Access Compliance Report

Public Rights-of-Way

(Curb Ramps)

Intersection ID: 29395	Main Street: REEDY_PLANTATION_RD	Cross Street: SILVERFIELD_LN	Location: NE
ADA ID: ACCE89EA1FE2	Ramp Type: PerpDiag	Initial Pass/Fail: Fail	Overall Compliance: No
Severity Score: 37.5			
Codes/Mitigation Info/Possible Solution		Field Measurements/Component Compliance

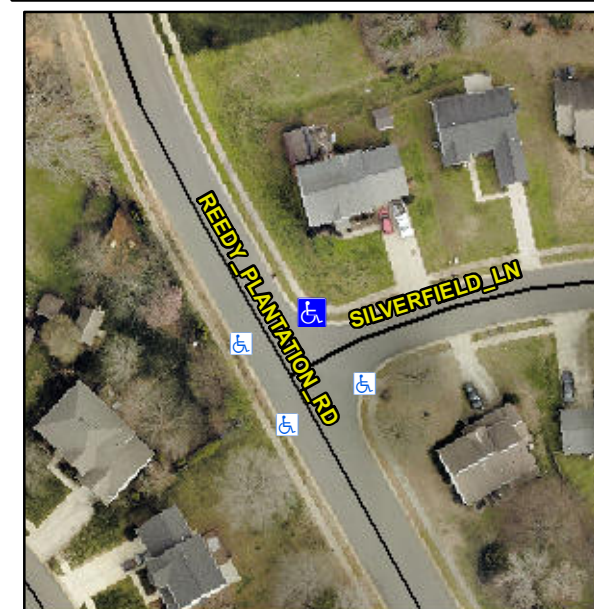
Remove & Replace Curb Ramp With Two New Directional Ramps or Equivalent.

R304.2.2, R304.5.3

Compliance	Description	Data	Compliance	Description	Data
N/A	Ramp Length (in)	48.0	No	Ramp Slope (%)	9.2
Yes	Ramp Width (in)	48.0	No	Ramp XSlope (%)	7.6
N/A	Flare Type LT	N/A	N/A	Flare Type RT	N/A
N/A	Flare Slope LT (%)	N/A	N/A	Flare Slope RT (%)	N/A
N/A	Flare Traversable LT?	N/A	N/A	Flare Traversable RT?	N/A
N/A	Landing Length (in)	N/A	N/A	DWS Provided?	N/A
N/A	Landing Width (in)	N/A	N/A	DWS Contrast?	N/A
N/A	Landing Slope (%)	N/A	N/A	DWS Length (in)	N/A
N/A	Landing X Slope (%)	N/A	N/A	DWS Full Width?	N/A
N/A	Landing Curb? (Y/N)	N/A	N/A	DWS Offset (in)	N/A
N/A	Shared Landing?	N/A			
N/A	Gutter Ponding?	N/A	N/A	Gutter Slope (%)	N/A
N/A	Gutter Lip Ht (in)	N/A	N/A	Gutter X Slope (%)	N/A
N/A	Painted X Walk1?	No	N/A	Painted X Walk2?	No
	X Walk 1 Direction	To N		X Walk 2 Direction	To S
N/A	X Walk 1 Width (in)	N/A	N/A	X Walk 2 Width (in)	N/A
	X Walk 1 Slope (%)	4.8		X Walk 2 Slope (%)	3.6
	X Walk 1 X Slope (%)	5.5		X Walk 2 X Slope (%)	5.2

N/A	Ramp inside XWalk1?	N/A	N/A	Ramp inside XWalk2?	N/A
	Road Slope (%)	6.6	N/A	Clear Space?	N/A
	Road X Slope (%)	0.8	N/A	Clear Space to XWalk (in)	N/A
N/A	Any Obstructions?	N/A	N/A	Storm Grate/Utility Hazard?	N/A
	Obstruction Type			Storm Grate/Utility Type	
		N/A			N/A
		Yes		Surface Condition? (G/P)	Good
